# UNITED STATES PATENT AND TRADEMARK OFFICE

10/010,246

<b>Office Action Summary</b>	<b>Application No.</b> 10/010,246	<b>Applicant(s)</b> SIXTO ET AL.	
	<b>Examiner</b> Darwin P. Erez	<b>Art Unit</b> 3773

## DETAILED ACTION

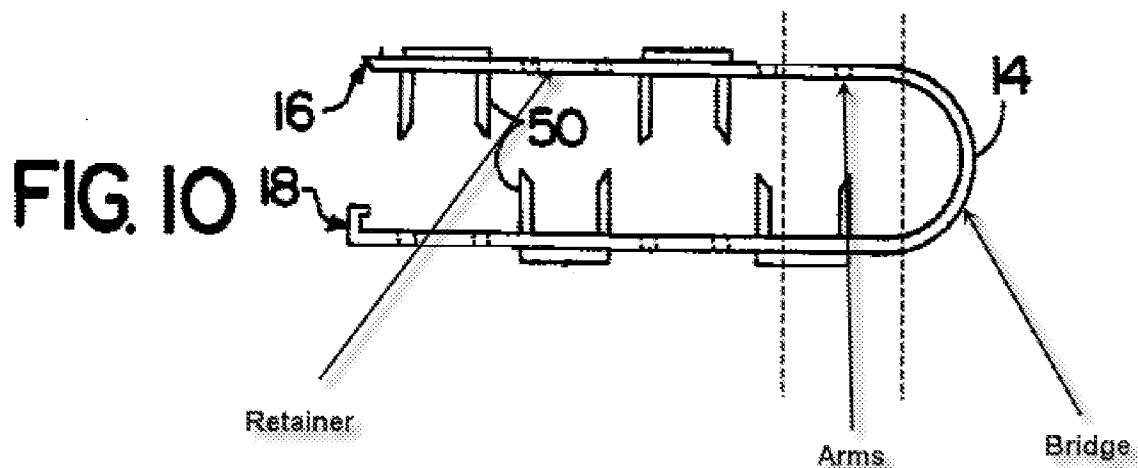
2. Claims 1, 2, 4, 17, 18, 21-23, 25 and 32 are rejected under 35 U.S.C. 102(b) as being anticipated by US 5,620,452 to Yoon.

Yoon discloses a surgical clip, as shown in the attached Fig. 10 below, which comprises a first arm; a second arm that is substantially parallel to the first arm; and a bridge connecting said first and second arms to form a substantially U-shaped structure. The arms also include a retainer portion attached thereto capable of penetrating tissue with force. The length of the retainer is fully capable of being at least 3.14 times the distance between the arms when the arms are substantially parallel (depending on how far the hashed line is manipulated). The retainer is also capable of being deformed (Fig. 4). Yoon also discloses the retainer having a tip portion **16** that has a thickness

smaller than the thickness of the arm; wherein the tip portion **16** is viewed as “sharp” (pointed). The clip of Yoon is also fully capable of retaining its substantially U-shaped configuration prior to, throughout, and subsequent to application (the amount of separation between the two arms merely depends on the amount of force used to press the arms together). The clip is also designed to be used with a clip applier capable of housing multiple clips (col. 3, ll. 41-59).
